## EAGLE MOUNTAIN PLANNING COMMISSION MEETING

**December 12, 2023, 5:30 PM**

##### **1.A [CONCEPT PLAN/DISCUSSION - Gardner Farms](#)**

## MASTER DEVELOPMENT PLAN

SHEET:  
**C-1**

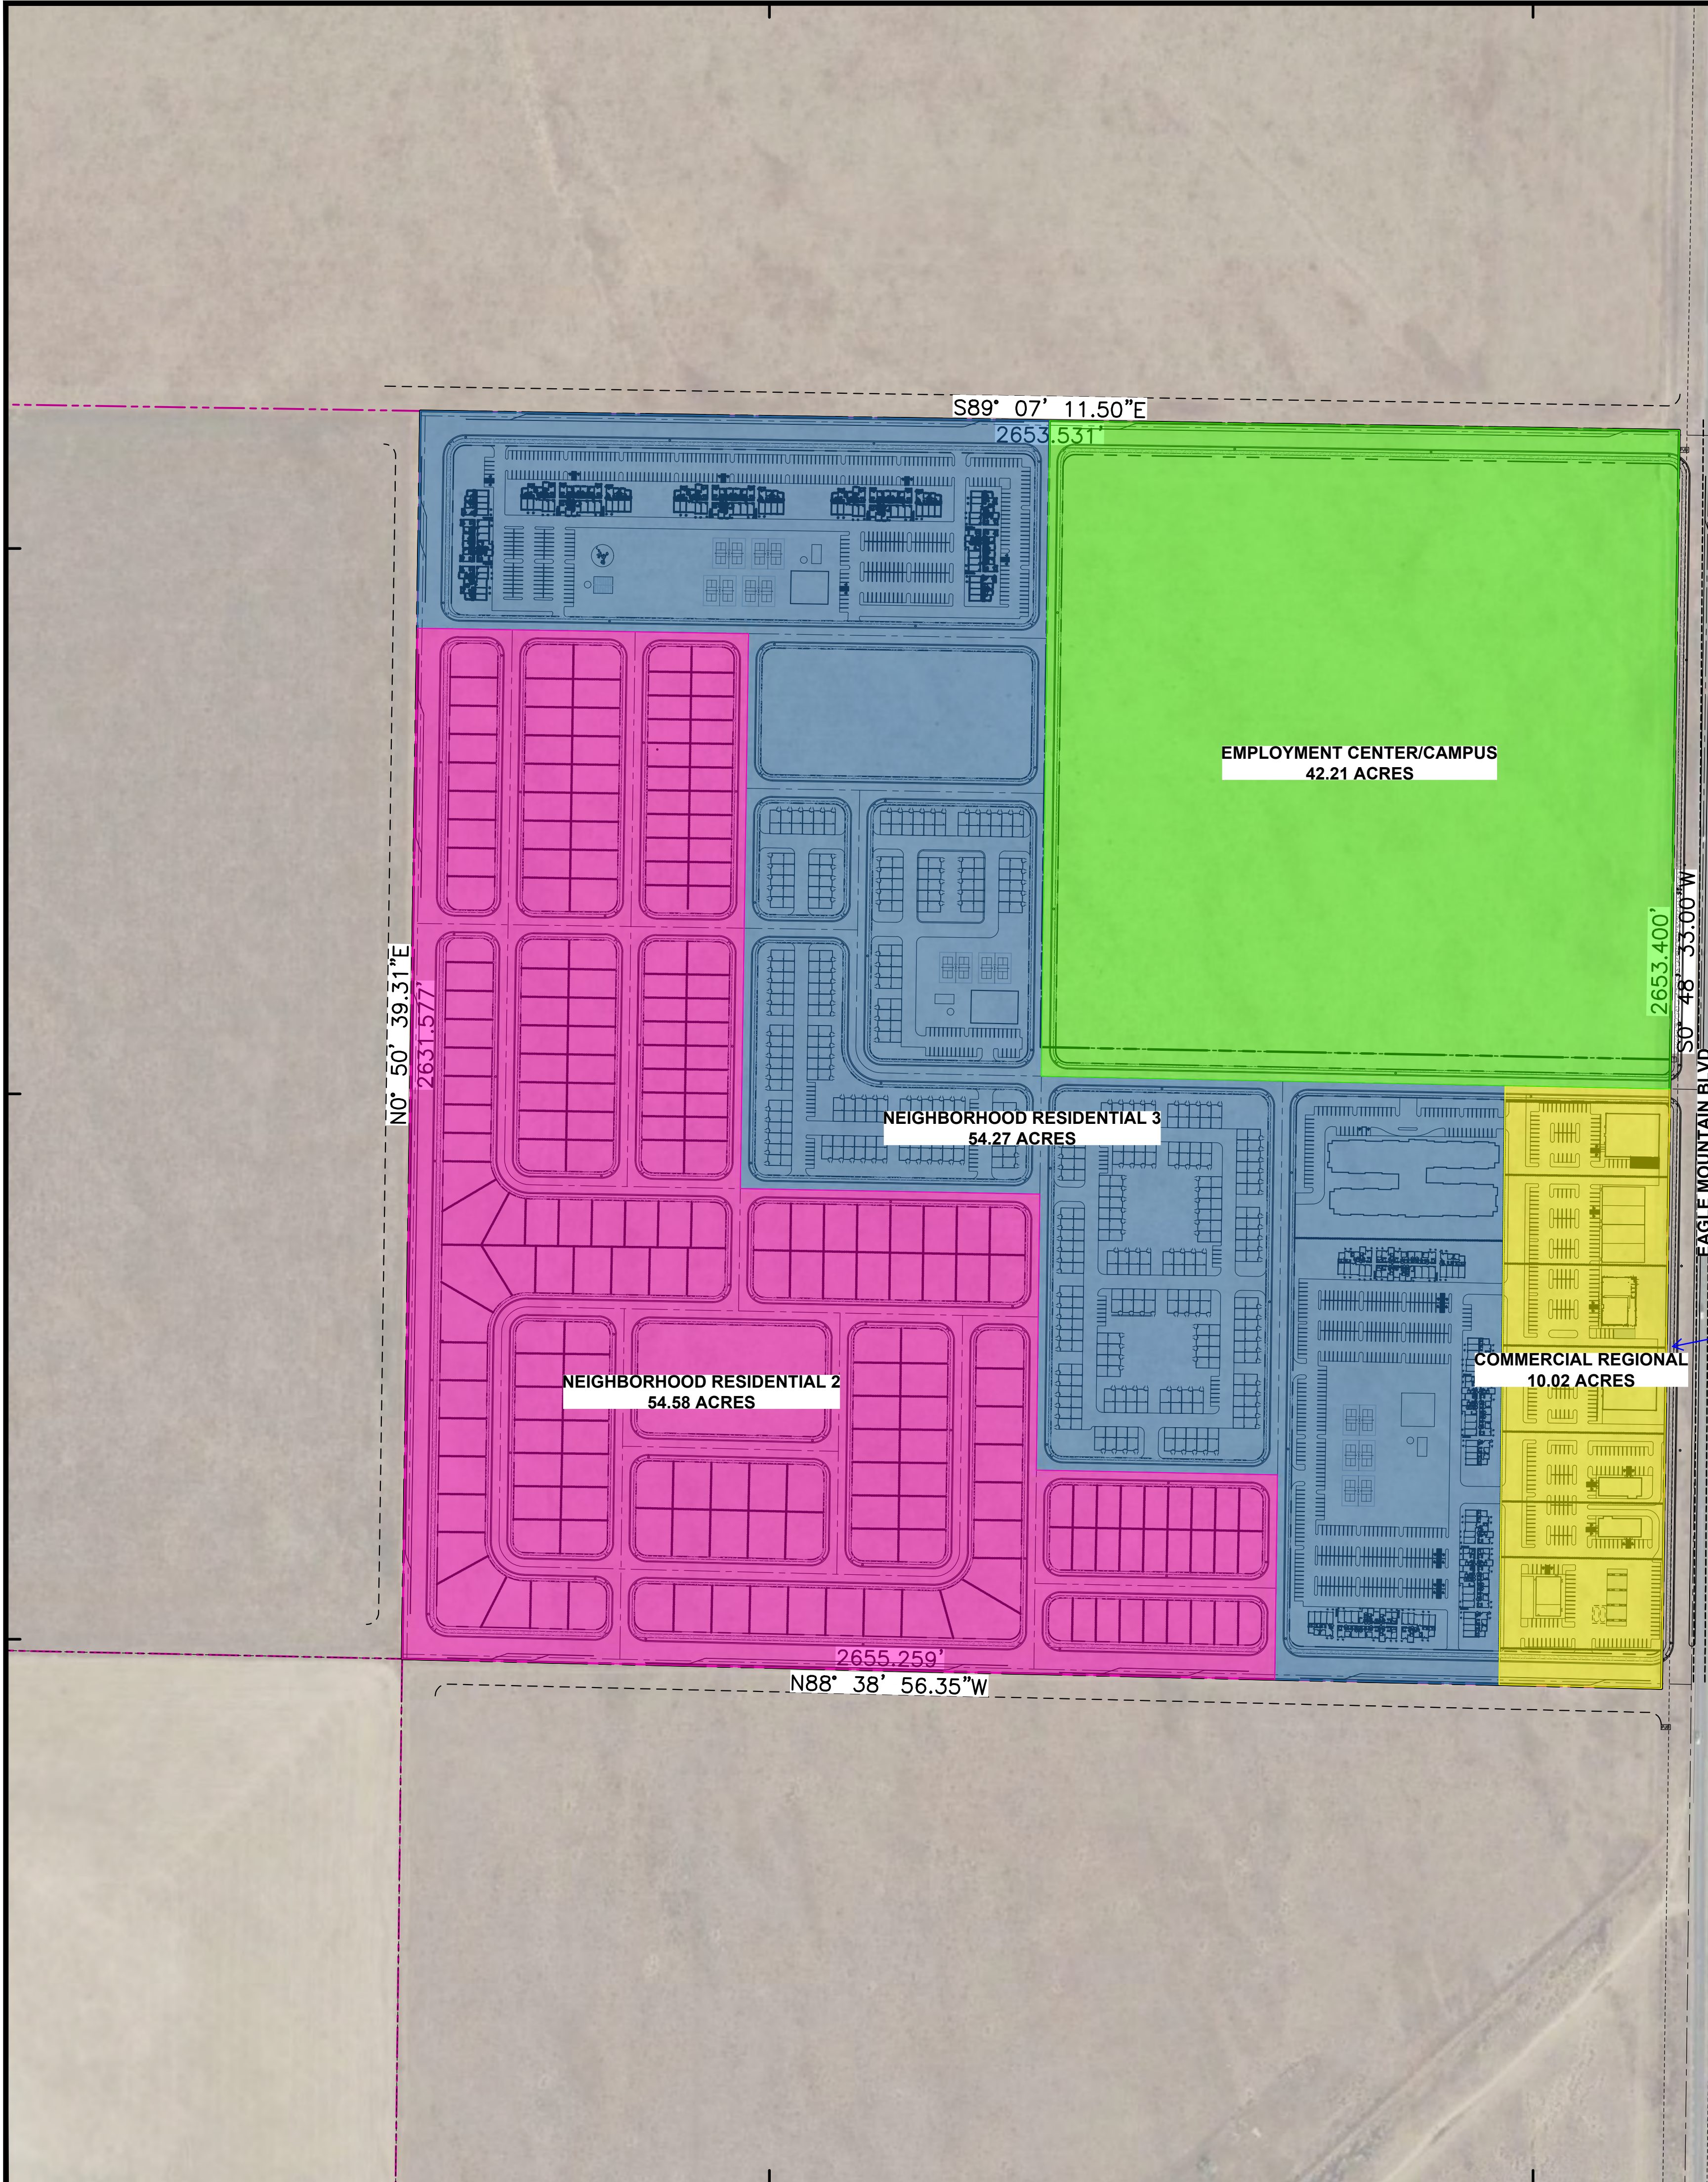
There are several lots less than 4,500 sq. ft. shown on the plan

C-4

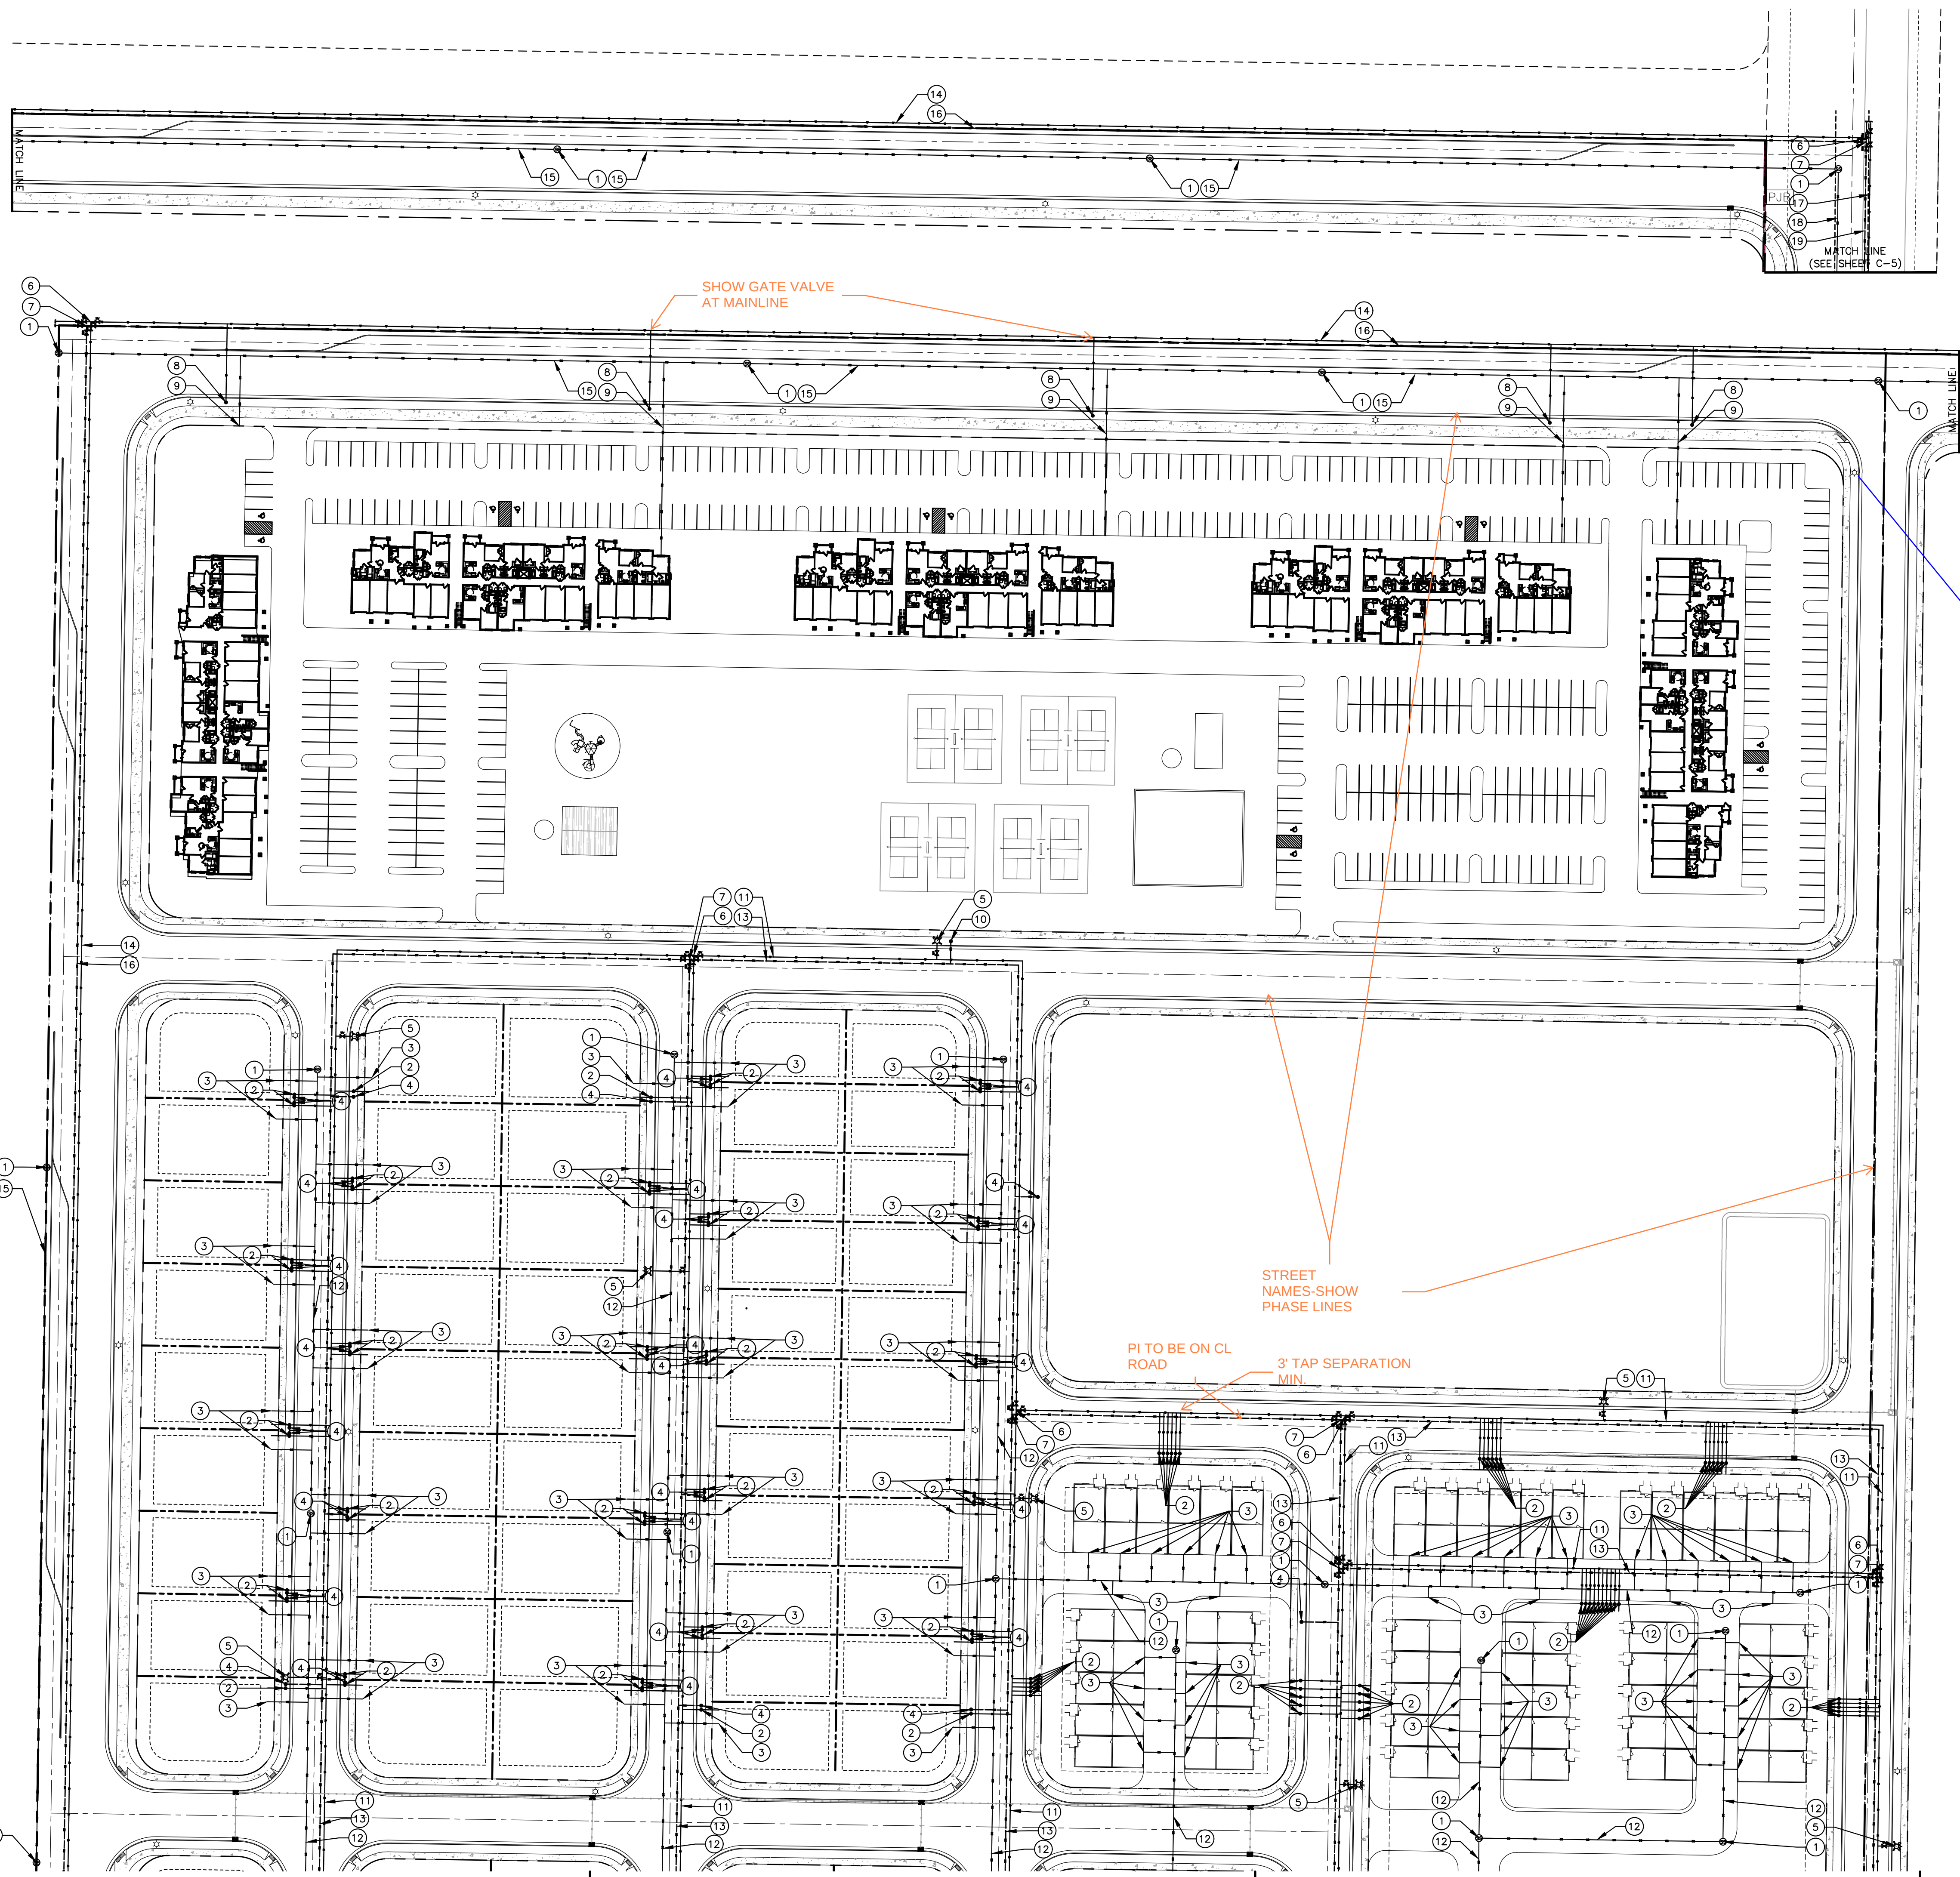
Code change on 12.5.23 City Council now allows up to 45 feet high if minimum 5:12 roof pitch or rooftop amenities are provided; 3 story max. Rooftop amenities, if used, are not factored into site amenities.

Use this base diagram to show fencing plan.

SHEET: **C-7**  
DATE: Nov 09, 2023

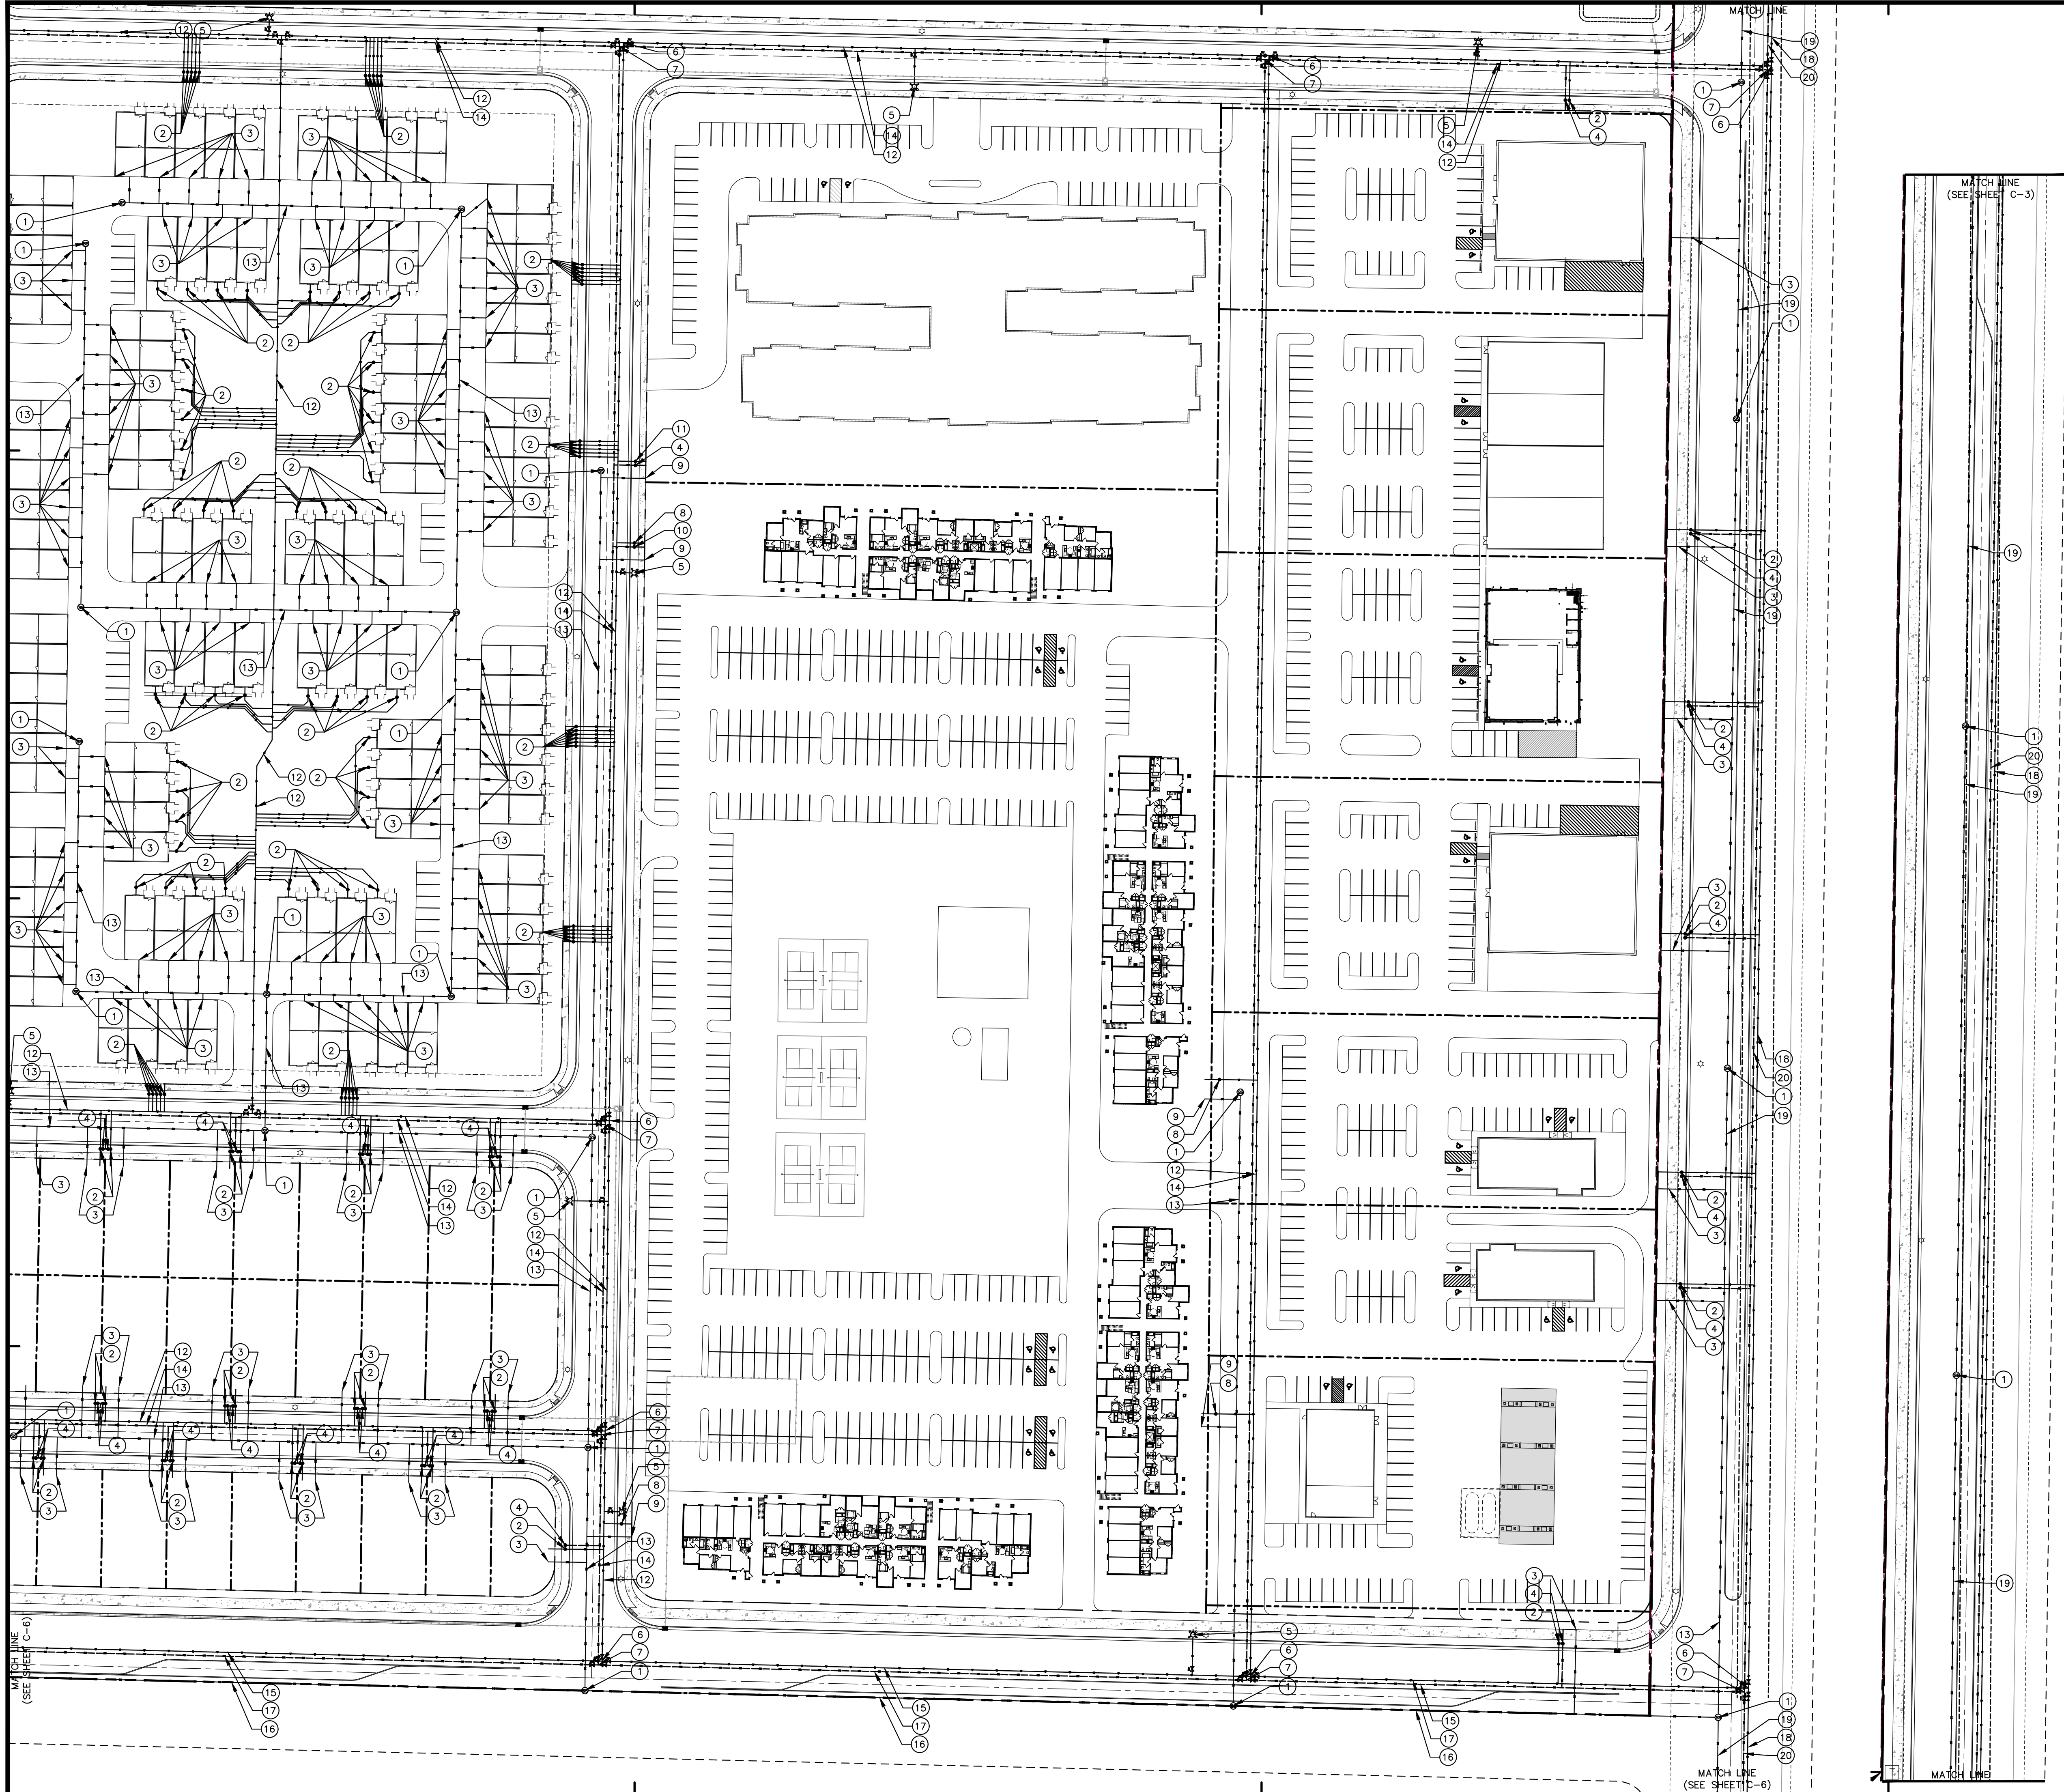
DDeVoogd/UFA 11/30/2023 - Comment on Sheet C7 Utility
